PLAN OF LAND
IN
NEWBURYPORT, MA
SHOWING
PROPOSED SITE IMPROVEMENTS
AT
2-6 MARKET STREET
(MAP 47 - LOT 59)

Subject: 2-6 Market Street Response to Engineering Review Comments

In response to design review comments provided by Phil Christiansen and Jon-Eric White, we have prepared the following responses. Please note these address outstanding issues. All previously addressed issues are not included.

16' VEHICLE EXITING P1-P2 AND 19' VEHICLE EXITING P9-10 SPACES

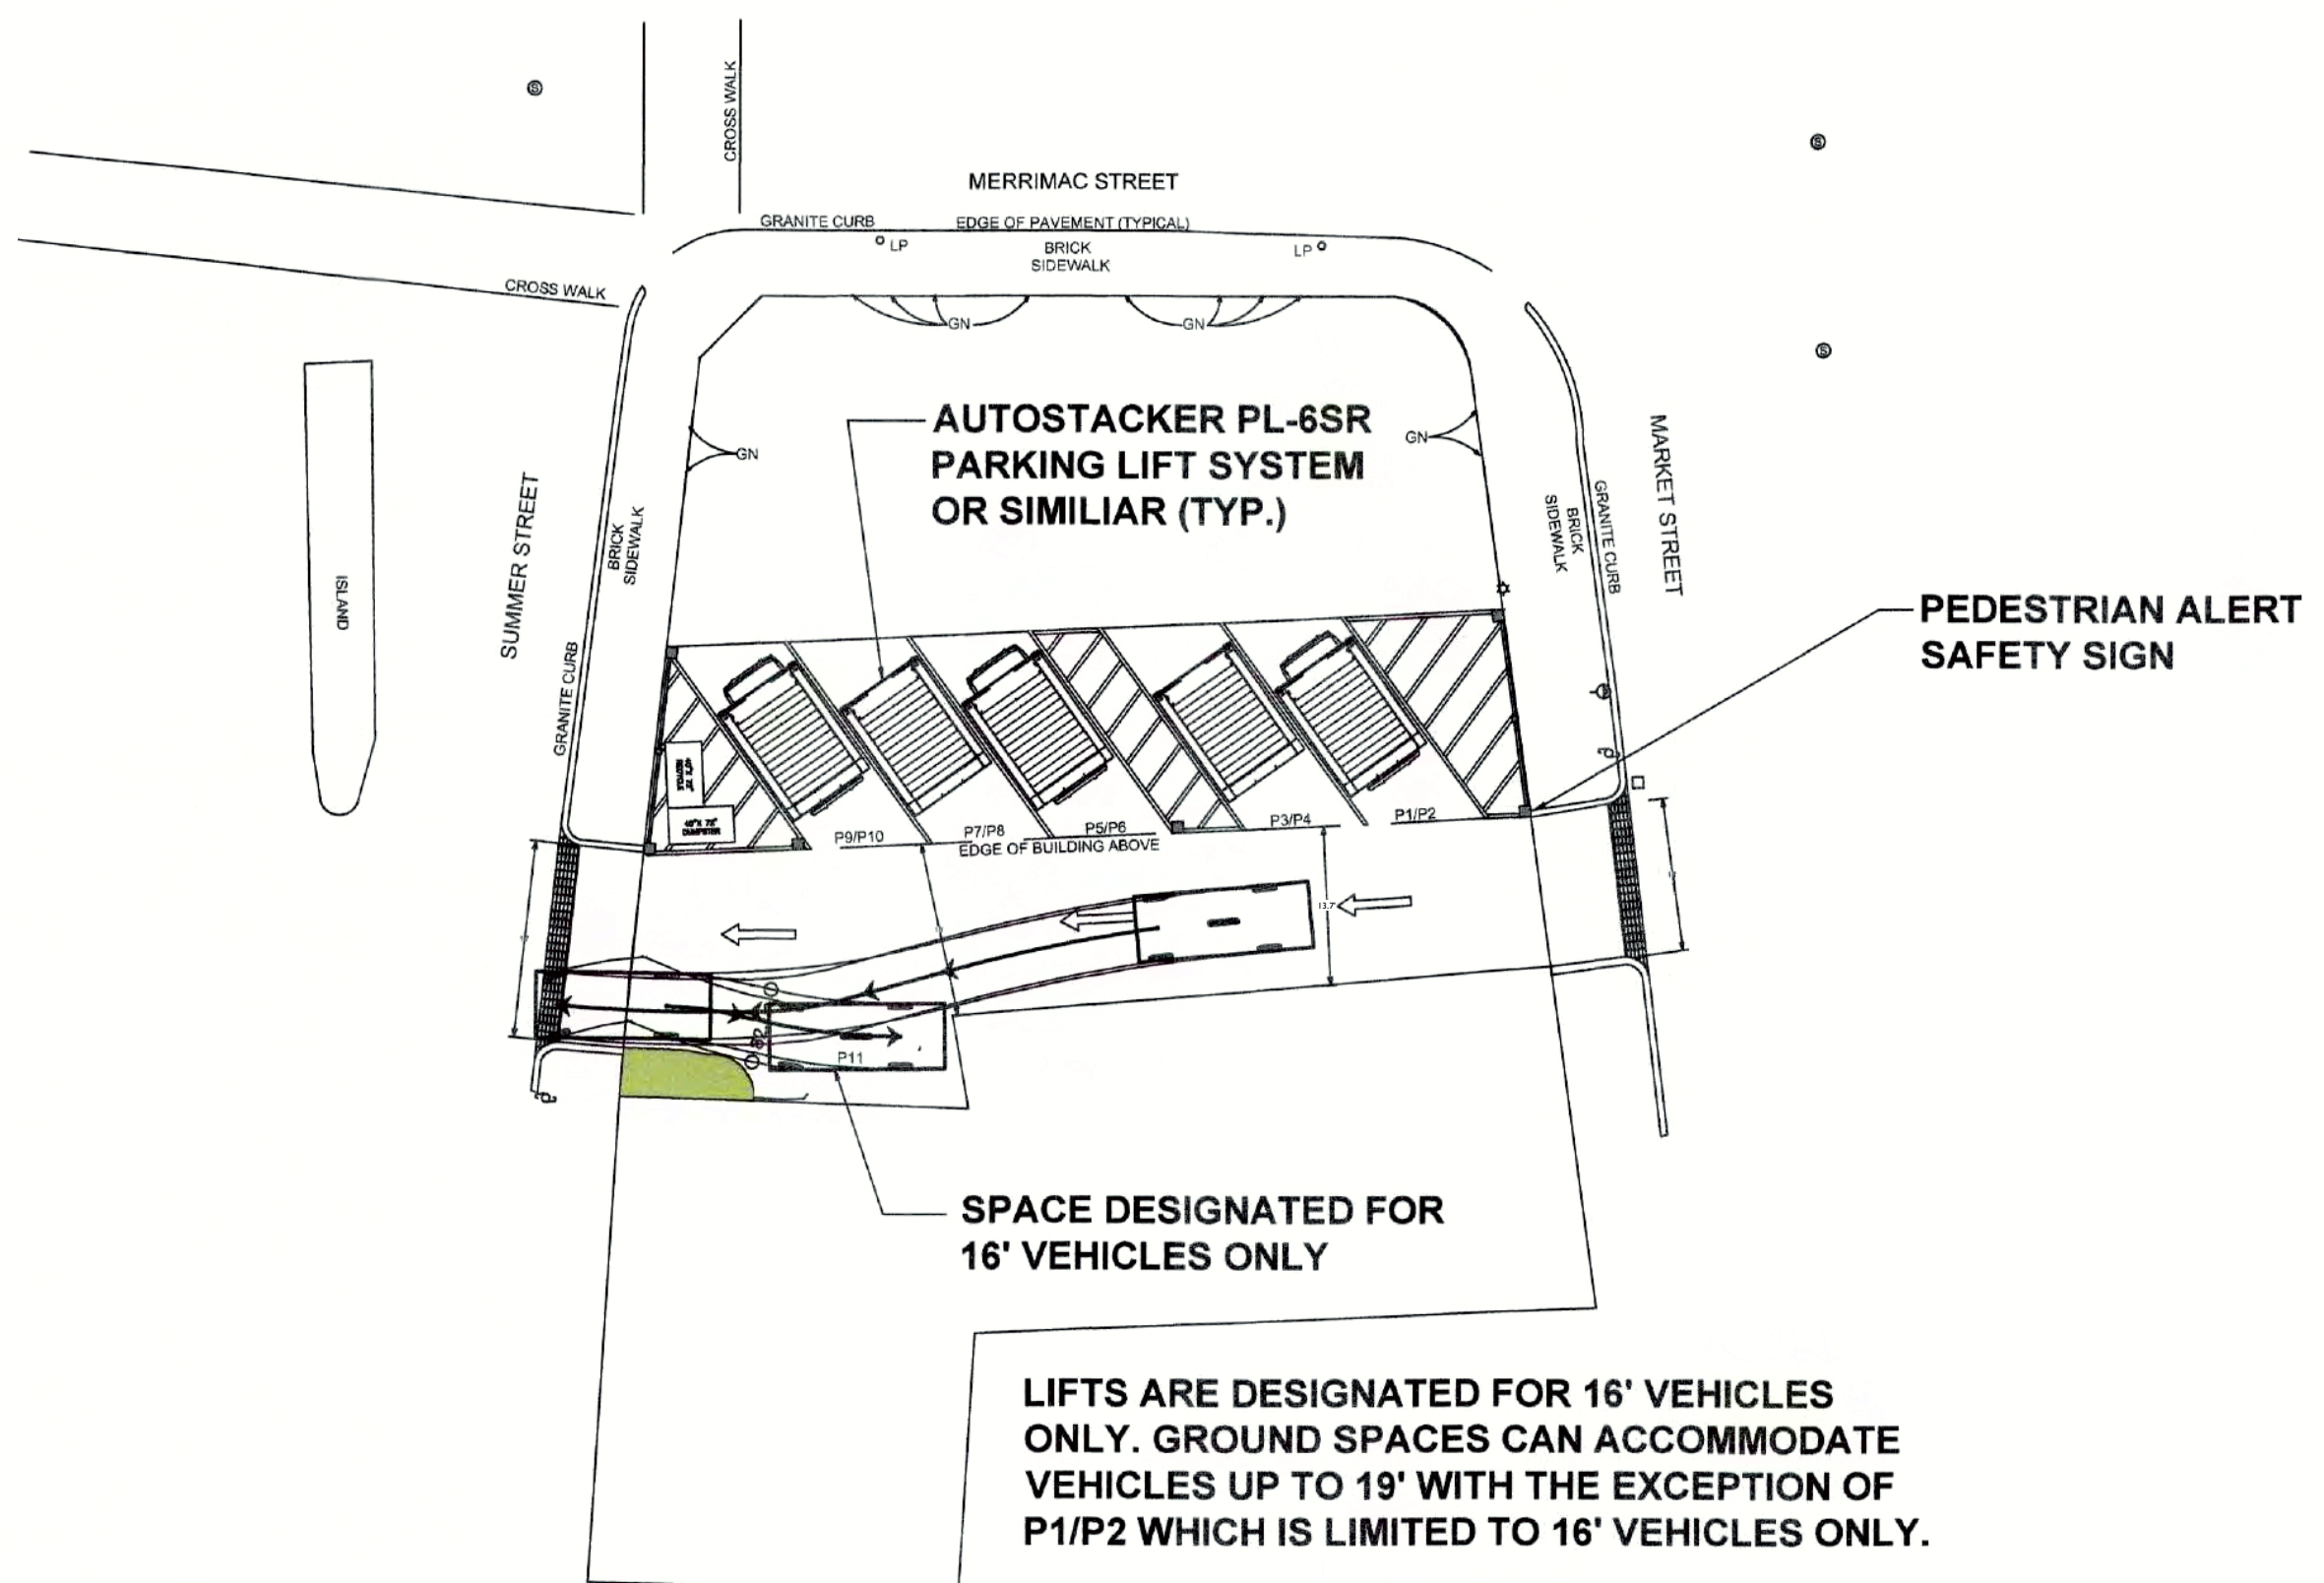
The limited isle width coupled with the use of the Autostscker PL-6SR Parking Lift Platforms make entering and exiting P1/P2 and possibly P3/P4 problematic. The platform width is approximately seven feet. An individual would have to back out straight until the front wheels were clear of the raised metal on each side of the platform. See attached pdf with a car shown in blue. Vanasse should provide turning movement diagrams for vehicles entering and exiting P1 and P3 using the proper aisle width and specifying the type or size of car used.

Response: 2 parking spaces have been eliminated and the parking layout has been revised. Vanasse has provided turning templates for the revised parking layout.
